Planning application 2020/4570

Current planning application 2020 4570

1.0 Executive Summary

Fig 1

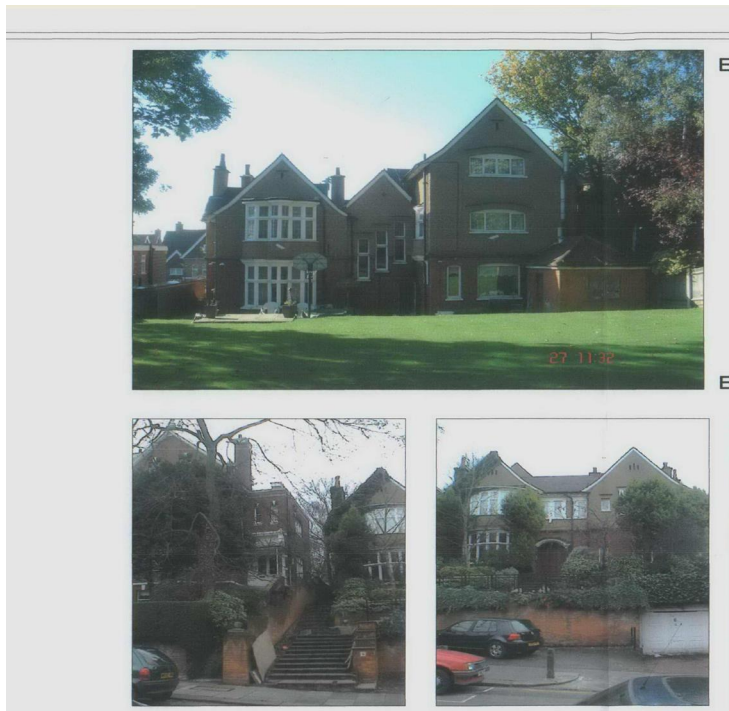
Through a series of planning applications spanning 2005-2008 (some of which were refused), the planning authority approved the transformation of the building from this period house with front garden, period features and a pleasing rear façade to
